# Montgomery Gateways

Stakeholder Report Back: What we Heard

June 2022

**Concept 1**

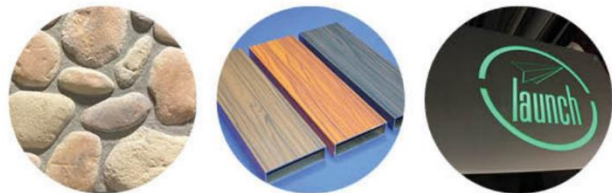
Supportive Themes	
General support	Portions of the feedback received expressed general support for this design option.
Critical Themes	
Inclusion of map of Montgomery	Many comments expressed a lack of support for the inclusion of the map within the gateway. Participants felt it is not aesthetically pleasing and confusing.
Lack of uniqueness, energy, and vibrancy	Some stakeholder feedback expressed a sentiment that this design lacks uniqueness, energy, and vibrancy.
Design is too 'busy'	Many comments received expressed feelings that the design is 'too busy' with a cluttered design.
General lack of support	Portions of the feedback received for this design expressed a general lack of support.
Other Themes	
Color	Feedback indicated mixed feelings towards the colors being used in the Gateway. Specific comments over the confusion over the intent of the orange line were submitted.

- Map is confusing. Too many Ms already
- I like it, but the "map" is not accurate at all. The streets do not go in straight rows as show and it is misleading for Bowness and Varsity areas. Someone just looking at this might think it is representative and accurate. Make the street more like they really are please!
- nice clean font. does a street map need to be included? is this what identifies Montgomery?
- I was born in Montgomery in 1958 and parents moved there since 1955. I still live in Bowness and drive through the mess the city created by so called street calming for Main streets alignment. There should be some Shouldice Heritage as they donated the lands for Shouldice park! There should be more greenspace or Green in the sign as we are surrounded by parks; Bowmont. Montalban, Shouldice and Edworthy!
- The Map is tacky. Why not just fill that space abstractly with blue and green

- That's not a map of Montgomery. It is a representation of the Bow. So do without the map and just stylize the river aspect. Doesn't need to be illuminated, garish and crass. Can have a reflective metal instead. Lengthen the M side, looks out of proportion.

- " -instead of illuminating (I'm assuming electrically), you could use reflective tape.-the elevation marker reads as a thermometer (albeit upside down); add the cross hairs -really liked the height and presence of this concept"

- It is clean but kind of lacks energy and vibrancy, either in colour or action. The blue streak is confusing because I think of the river and it goes oddly through the community.

- Not a big fan of the orange line
- Too dull to show a welcoming energy. Doesn't highlight nature well enough.
- Sure is ugly
- Don't like the map. Especially as it's presented in the concept.

- Love the style but the road map/river graphic looks odd and at a glance while driving doesn't make much sense or provide meaning to a driver
- I am not sure about the map. It would be more engaging if it were a functional map of the area. It could be artistic but it would for sure be useful for pedestrians and cyclists at those junctures if the map showed the main roads and sights along them.

- Quit destroying the roads. It's making things worse. It's horrible to drive that way now. Take out the bike lanes. It's so dangerous.
- Materials used are good choices. Lettering feel a bit too modern - maybe use a serif letter shape instead? Not a fan of the streetscape background - could we incorporate more trees and sky instead like in the one photograph? I do like the river running through, the M design, and the rocks at the bottom. I don't understand what the long orange pole thing is.

- It's awkward looking with the long leg of the M.
- "The overall structure is way too small and easy to miss. It does not feel welcoming. It looks insignificant. Not something Montgomery residents can really be proud of. The 'Montgomery' script is too small and the vertical format is not easy to read at a glance. The Evanston neighborhood sign is an example of a good size and structure that really defines the entry in to the neighborhood. The sign feels cold and bland. It needs some greenery (flowers, shrubs, plants) to really associate with nature."

- Too much happening, concept isn't very special or specific to Montgomery
- The map is confusing because it appears that the river runs through the street which is inaccurate. I like the idea of it being lit up. I would prefer a design that spans the road and is more flashy, this feels a bit boring to me. Like the idea of natural elements but trees/greenery would be nicer rather than the river rocks.

- I like the rocks at the bottom. I don't like the stretched out M or the map. It would be good to include the "est. 1911" part.
- How about you just save the tax dollars, nobody wants this.

- It's just not inspiring. I see what the designer(s) tried to do, but it's like too many busy elements that don't fit together well. The river rock doesn't match the aesthetic of the sign. The river shape is being distracted by the grid of streets behind it. The 'M' is asymmetrical. The orange line has no purpose. The plain 'M' sculptures in the neighbourhood have more impact than this sign.

**Concept 2**

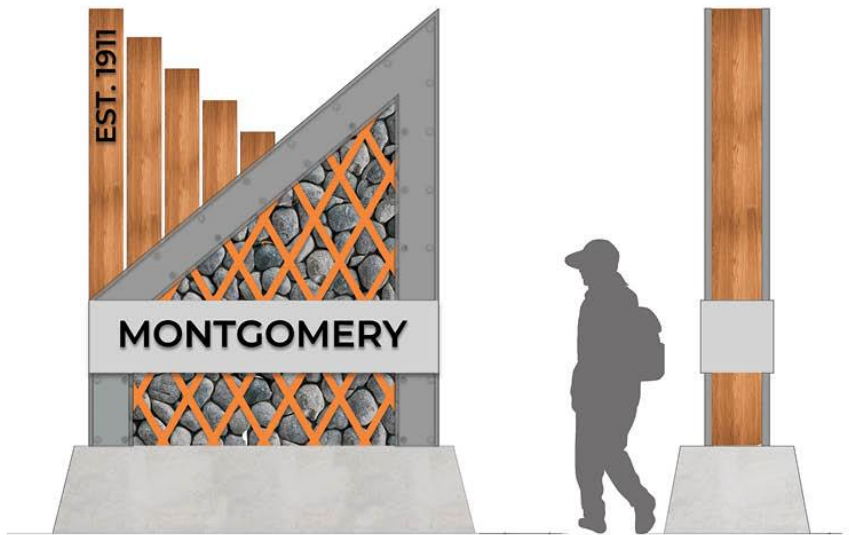
Supportive Themes	
General support	Portions of the feedback received expressed general support for this design option.
Established date	Feedback indicated support for the inclusion of the established date of Montgomery on the gateway.
Critical Themes	
Industrial feel	Feedback indicated criticism that the materials used in the gateway give a very 'industrial feel'.
Color	Stakeholder feedback felt the design lacks vibrant colors.
General lack of support	Portions of the feedback received for this concept and project expressed a general lack of support.
'M' symbolism	Stakeholder feedback expressed confusion over the sign representing an 'M' for Montgomery and felt it was unclear.
Other Themes

Materials	Many comments were received regarding the materials used. It is recommended the viewer read the verbatim comments for a fulsome understanding of this feedback.
Diamond Pattern/ Cage	Many comments were received regarding the diamond pattern and cage were received. It is recommended the viewer read the verbatim comments for a fulsome understanding of this feedback.

- Awesome! Love the abstract character!
- Don't like it. Not clear that this is an "M" and the wood boards will be subject to damage. #1 is much better
- Less industrial looking. Like the shapes and lines, very clean.

- Don't like the orange color on the lower part.
- Caged rocks. Why caged rocks?
- Looks like someone couldn't decide whether to use metal, wood or rocks. Heck, let's just all throw them in.

- Do not like the colours or the shape.
- Clean and modern.
- I like the "EST. 1911". Not sure I like the wooden posts as part of the large "M" it doesn't show as well.

- I like the addition of an established date. I don't like the red cage for the rocks. I would like it better with a less noticeable rock cage. Too modern and conceptual - I don't see how a thriving community is represented in the concept

- The diamond pattern just comes across as a fence, especially at a glance.
- Grid suggests a fence or wall, less natural and more prison
- The sign should be similar to what we have, colourful and happy children playing. This proposal reflects the low quality infills being built now.

- the diamond pattern looks too much like steel girders or bridge support
- Looks like a hydro-electric project.
- Too industrial. Needs colour: Trees, Rockies + Bow River.

- Not as busy but no distinctive 'M'
- Would take away the wire on the rocks. It looks like an orange prison. Free the rocks! Otherwise love the look. But would pick number 1 specifically because of the wire on the rocks

- "Too small and insignificant. Too industrial and cold. Not welcoming. The orange diamond patterned steel is very tacky. Nothing about this says unique and thriving. Needs greenery (flowers, plants, shrubs) to associate with nature. Needs good accent lighting/leds to make it stand out at night."

- I like that it includes EST. 1911. I like the wider M. I like the design in general but I don't love the grates in front of the rocks - but not sure what the alternative would be - perhaps having the grates in grey, black or blue would be better?

- This is definitely better than concept 1. The orange mesh is very distracting. I like how it has the shape of an 'M'. I think it could look better if you lost the whole part under Montgomery to the top of the base. Then it's shaped even more like an 'M'.
